A14
**Cambridge to Huntingdon
improvement scheme**
Development Consent Order Application

Response to ExA's Second Written Questions:

Principal Issue 13 Water Issues

August 2015

Figure 13.1: The predicted change in peak water level on the river Great Ouse for the 1% AEP plus climate change event

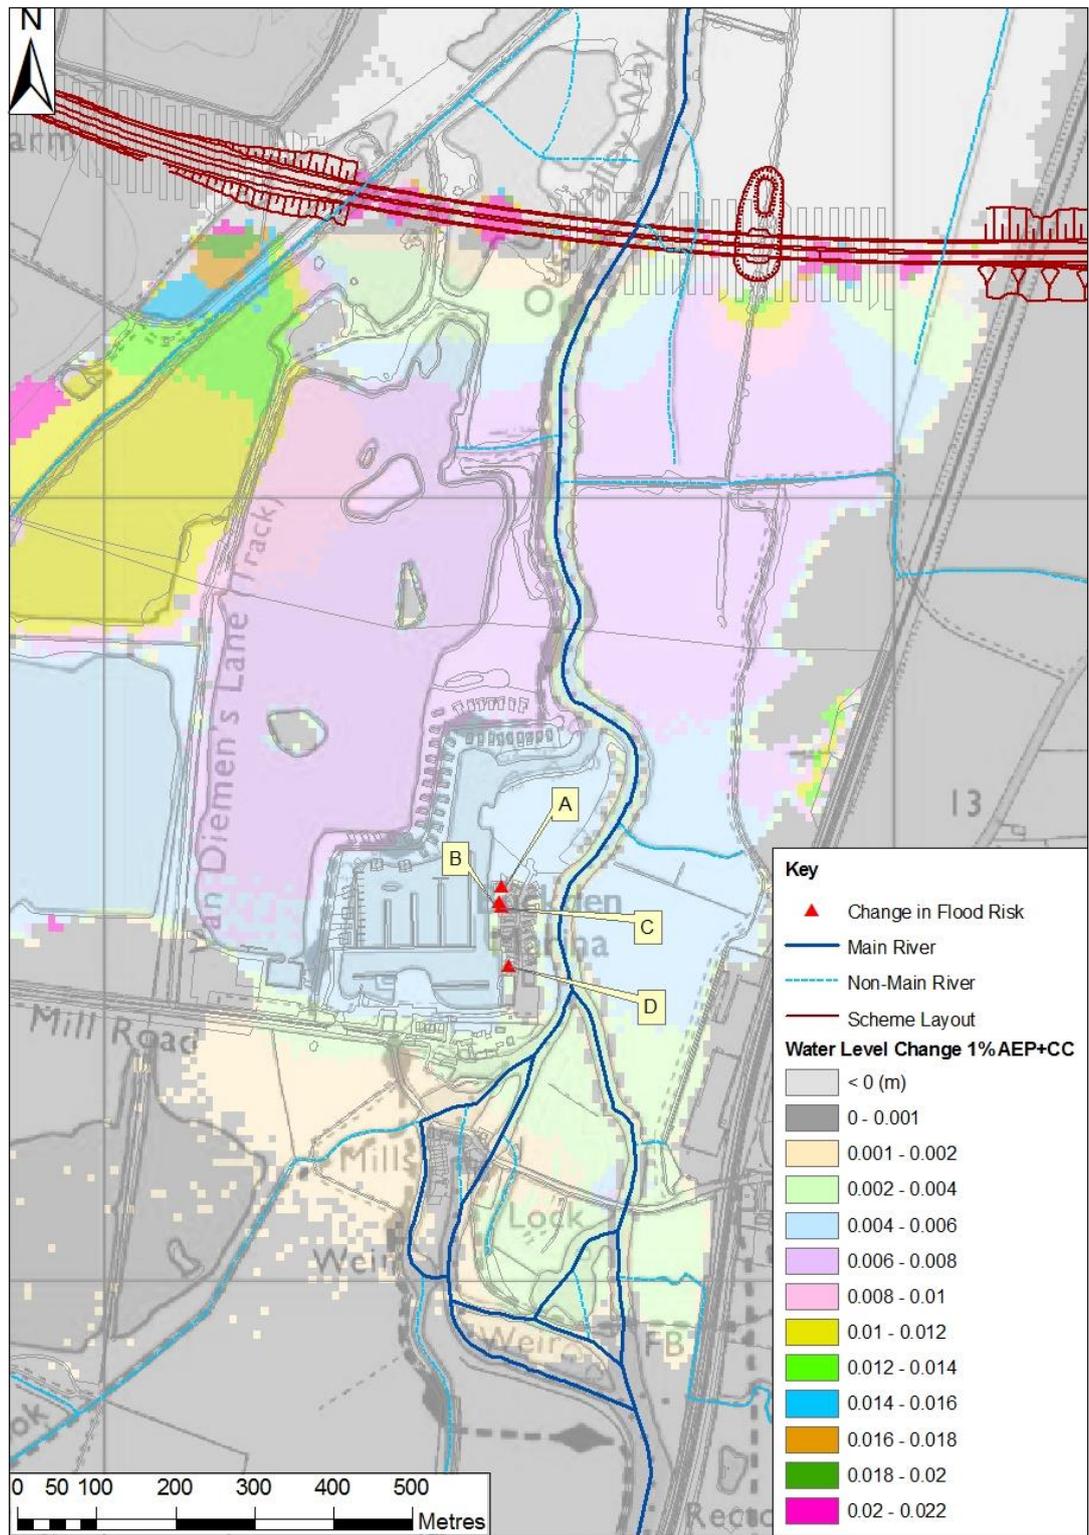
More than 4 properties are located on the eastern side of Buckden Marina. Notwithstanding that property threshold levels are said to be typically between 100-150 millimetres above ground level, do the additional properties have particularly elevated floor levels? How do the existing and with-scheme water levels relate to the actual floor levels of these properties? (REP2-014, para18)

7. For clarity, there are only four properties that are affected. A property threshold level survey has been undertaken to confirm the threshold / floor level, ground level and height above ground of the properties on the eastern side of Buckden Marina. Four properties are predicted to experience a change in flood risk band as summarised in Highways England's response to written question 1.13.4 (*Response to ExA's First Written Questions: Report 13 Water Issues*, Applicant reference HE/A14/EX/40, PINS reference REP2-014). The four properties are indicated in Table 13.1.

8. The predicted change in water depth is above ground level and not property threshold, and therefore the properties would not be flooded.
9. The majority of properties in this area will not experience a change to peak flood levels and consequently flood risk threshold as a result of the new crossing as indicated by the grey shading in Figure 13.1. Four properties will experience a change in flood risk threshold as indicated in Highways England's response to written question 1.13.4 based on ground levels. However these four properties have threshold levels at least 0.6 metres above the 1% (1 in 100) Annual Exceedance Probability Event (AEP) peak flood level plus climate change under both existing and with-scheme scenarios. An updated table 13-2 from Highways England's written question 1.13.4 is augmented below with the threshold levels and the freeboard between the peak flood level and the property threshold levels for the existing and with-scheme scenarios.

19. A property threshold level survey was undertaken in August 2015 and has identified that under the existing and with-scheme scenarios, the four properties will retain a minimum of 600 millimetres between the 1% (1 in 100) AEP plus climate change peak water level and their property threshold level. The properties will not flood under either scenario.

20. While the properties will experience a rise in peak water levels for the 1% (1 in 100) AEP event of up to 6 millimetres this is considered to be a Neutral flood risk impact under the Design Manual for Roads and Bridges impact assessment methodology.
